Bulletin No.: L16-002
Release Date: 3/16/16
Effective Date: Immediately
Supersedes: N/A
Completion Date: N/A
Page: 1 of 2

SERVICE BULLETIN

Ride Manufacturer: Larson International Inc. **Affected Production Dates:** All
Ride Name: FLYING SCOOTERS **Affected Serial Nos.:** 7-25

Abstract Of Issue: Inspection of the sweep assembly vertical tubes (L340000 item 1).

Detail Of Issue:

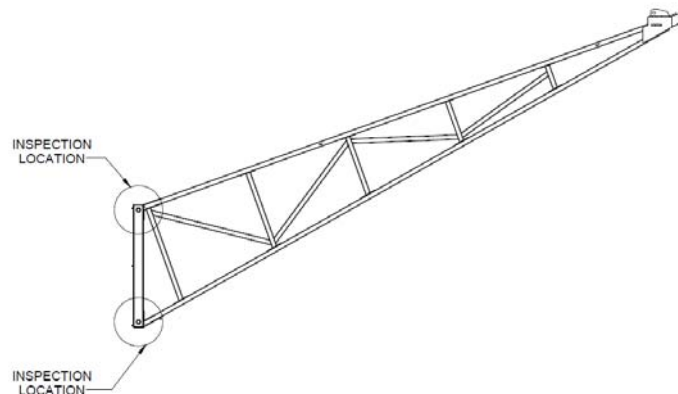
Reason for Release: Cracks have been found in these locations. These specific areas need to be examined during your daily and annual inspections.

Action To Be Taken: Visually inspect the vertical tubes of all sweeps for cracks. Any visual indications shall also have NDT MT performed to determine the crack length. Contact Larson International to determine if the sweep can be repaired. Add this service bulletin to the ride manual as detail for the daily inspection and add an annual NDT MT inspection of these areas.
